# PERMIT APPLICATION REVIEW

## **SADDLE RIDGE CLUSTER SUBDIVISION**

**SPORT HILL ROAD & CEDAR HILL ROAD  
EASTON, CONNECTICUT**

**RE: REVIEW OF INLAND WETLANDS PERMIT APPLICATION 25-733**  
**Saddle Ridge Cluster Subdivision**

FIGURE B: ALTERNATIVE ACCESS TO SITE  
FROM SILVER HILL ROAD  
Saddle Ridge Cluster Subdivision, Easton, CT

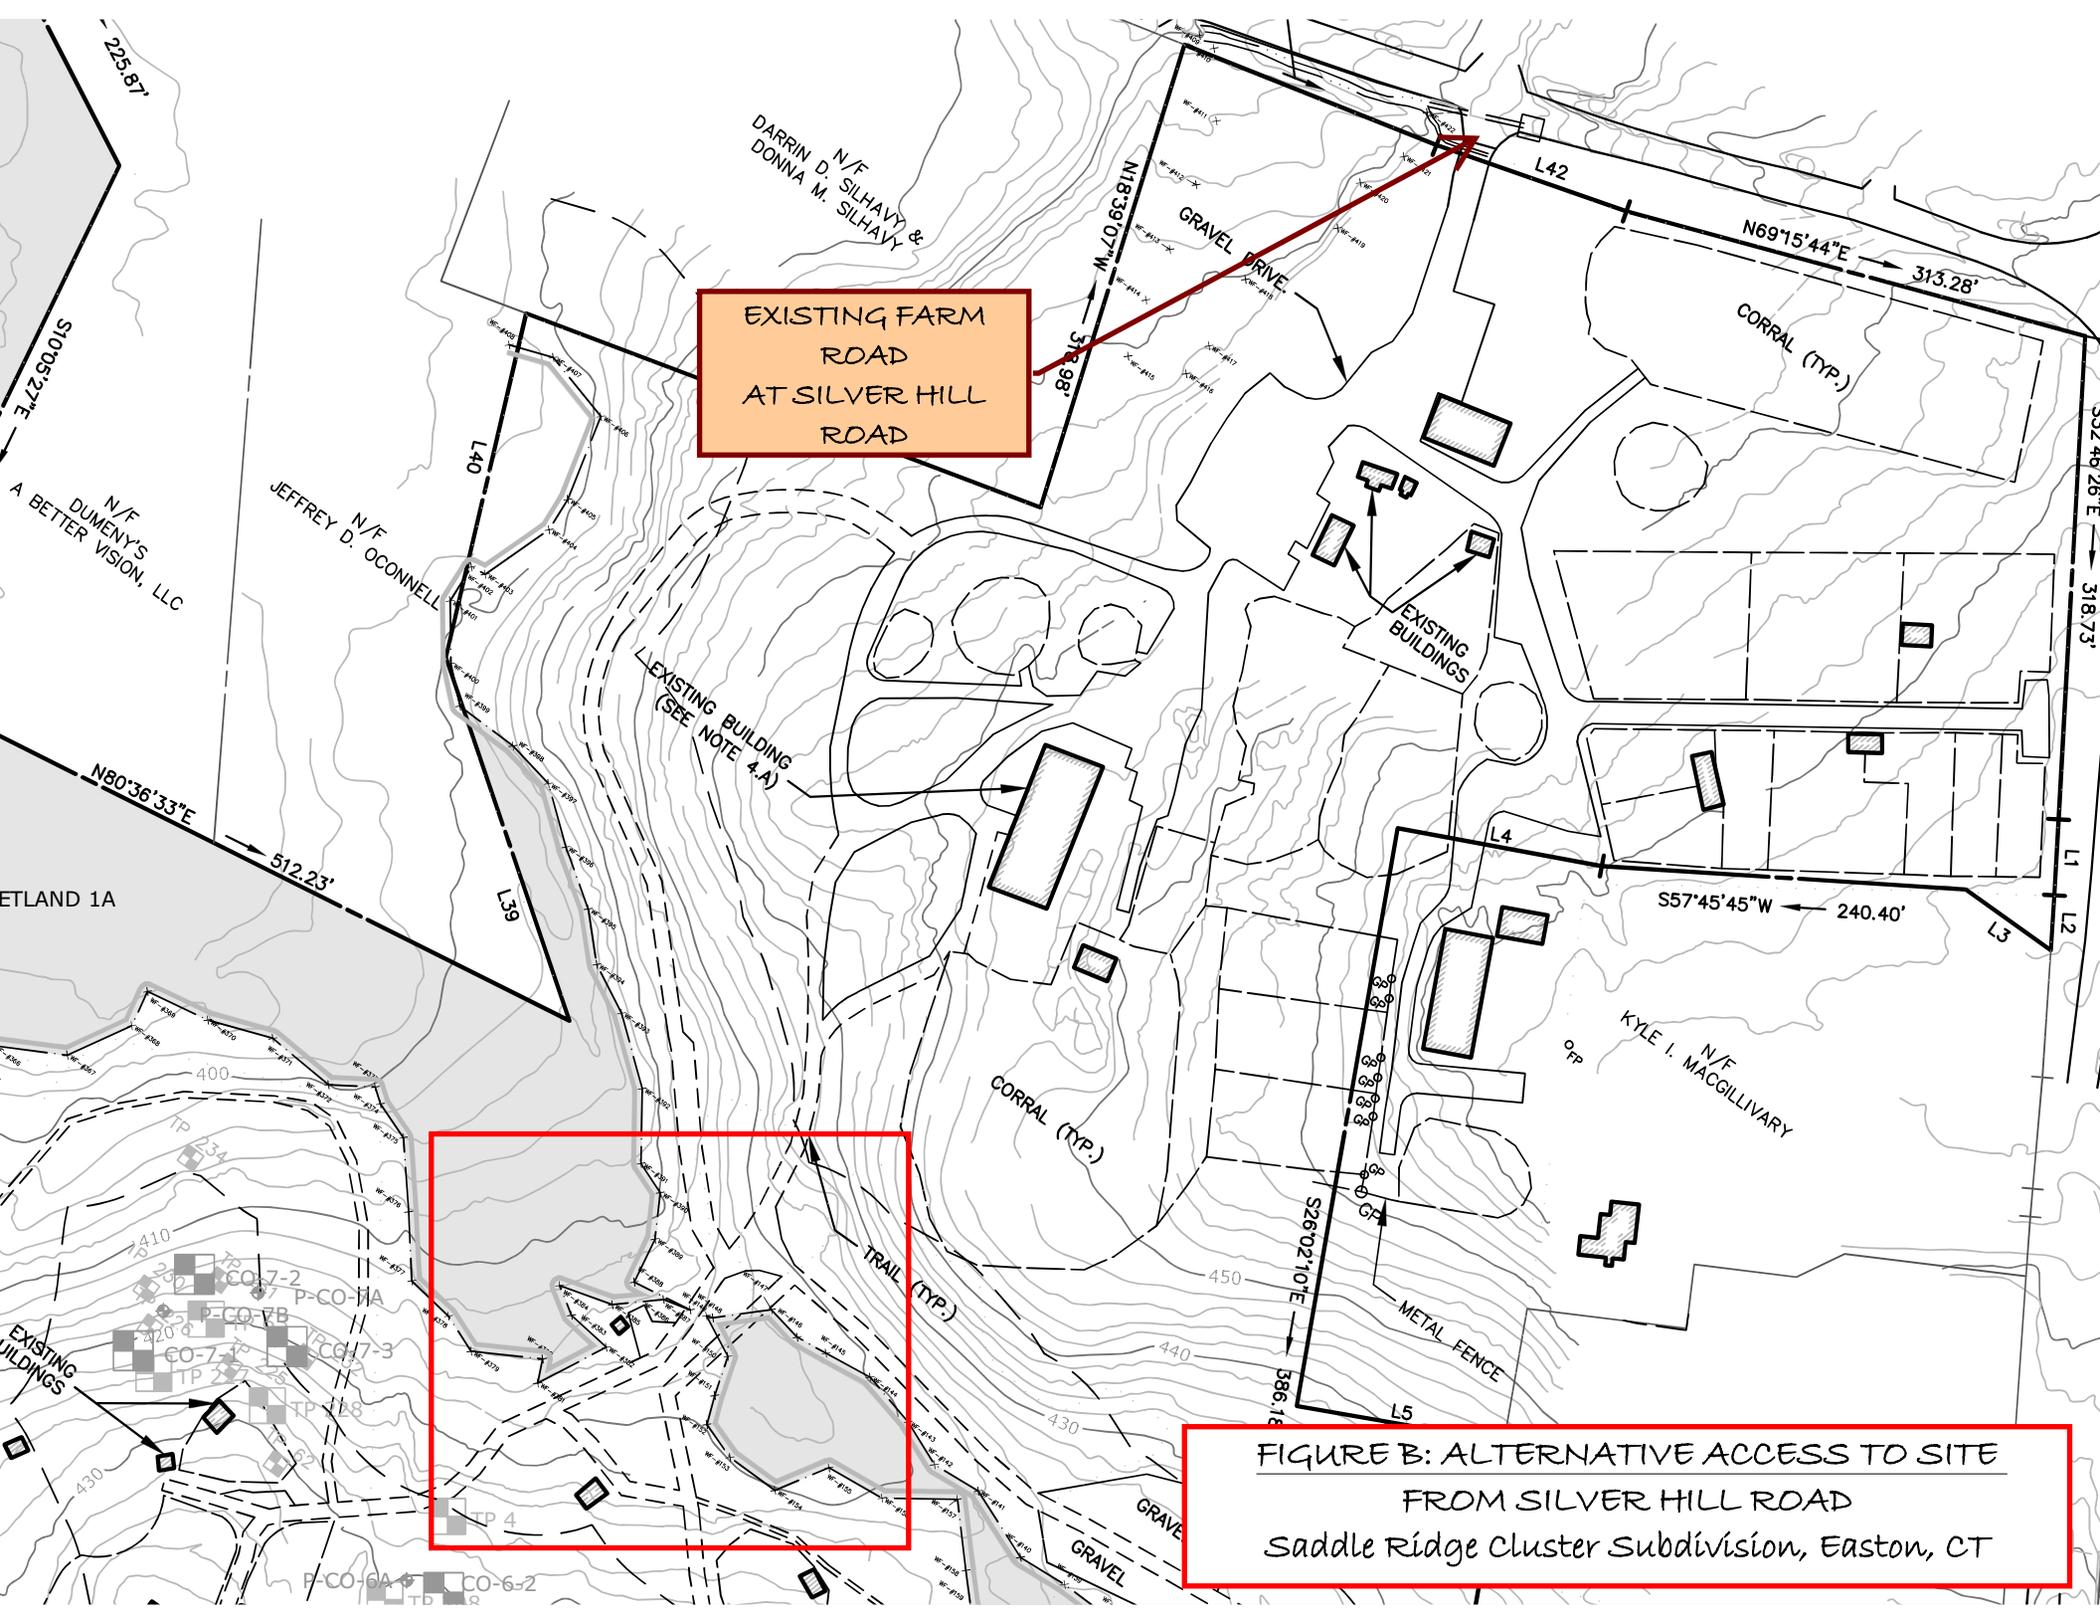
Plan Sheet EX-1 of the submitted plans (February 2, 2026, revision), depicting the full extent of the subject property, indicates the presence of an existing farm road corridor extending between Wetland 1A to the northwest and Wetland 1B to the southeast, providing potential access from Silver Hill Road (see Figure B, attached).

This corridor crosses an area identified in the SSES February 2, 2026 report as previously disturbed wetland, including the presence of an existing culvert and fill material. The SSES report proposes restoration of this area, including removal of the culvert, removal of fill, and replanting with native vegetation.
